## URGENT WELD BULLETIN

Cottrell, Inc. has received reports that there has been some confusion on the SB006 bottom gusset welding procedures on the C-10LTA and C-10LTB trailers. Please see photos below of examples of the correct and incorrect weld procedure for this area. Picture A shows the correct weld procedure for welding the top of the gusset to the front post. Picture B demonstrates an improper installation with a weld missing at the top of the gusset, and also demonstrates improper wrapping of the weld at the corner of the gusset. Attached is a drawing showing the correct welding procedures and weld locations. If you currently own a C-10LTA or C-10LTB trailer, or if you have performed the SB006 update on a customer's C-10LTA or C-10LTB trailer please inspect immediately. If not properly welded, please contact Kris Ransom at 800-827-0132 ext 301 for a resolution.

PICTURE 'B'

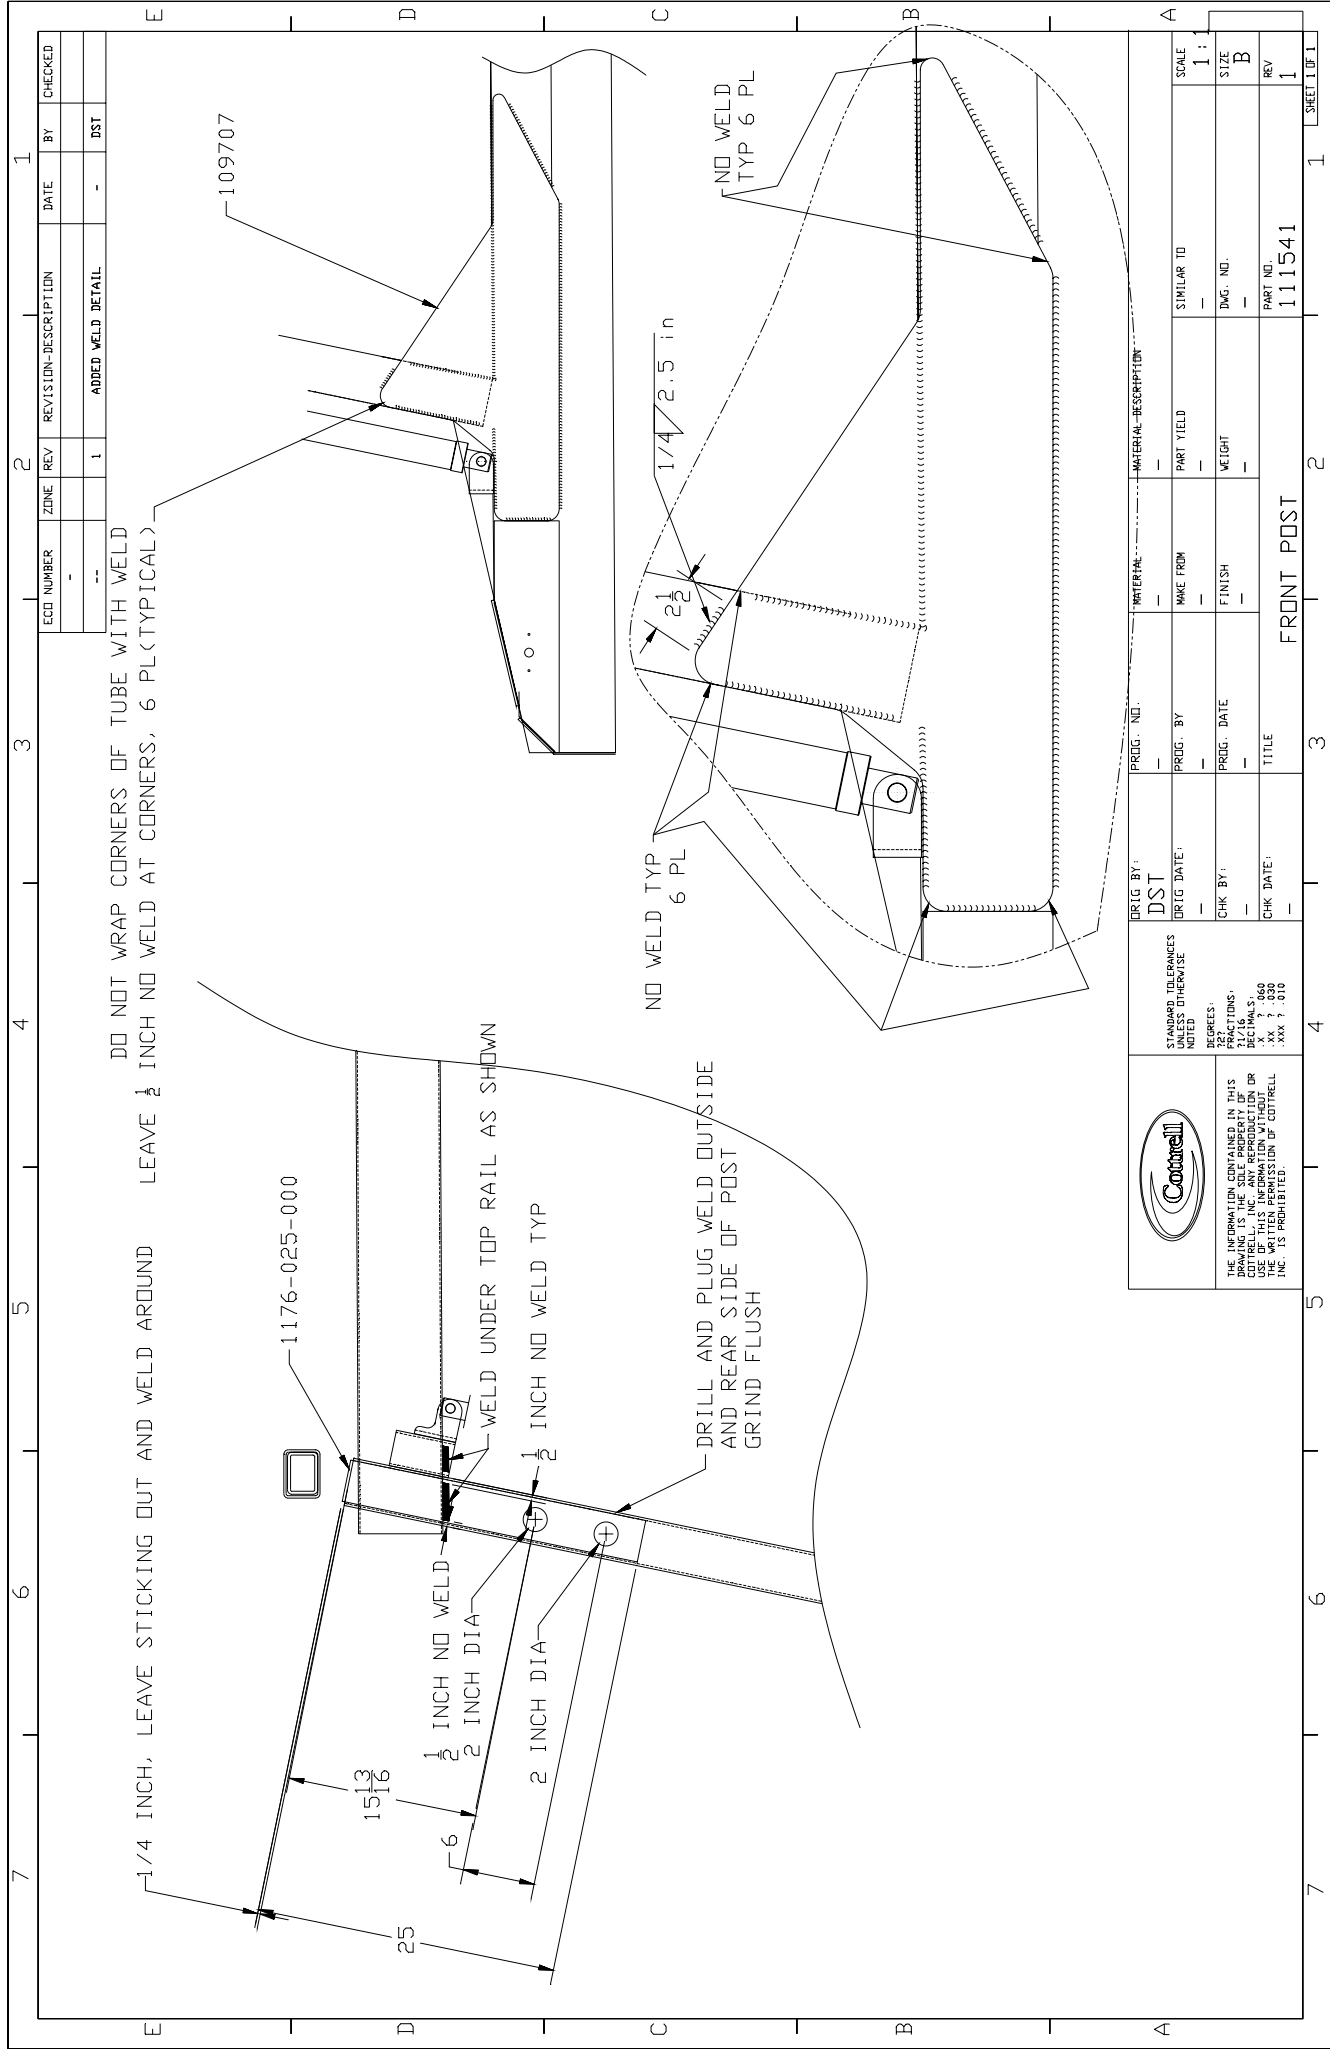
INCORRECT

- No weld at top of gusset
- Weld wrapping corner of gusset

CORRECT

- 2 1/2" weld at top of gusset
- No wrapping of welds in corners

Review following drawing, #111541, for correct welding specifications and procedures.
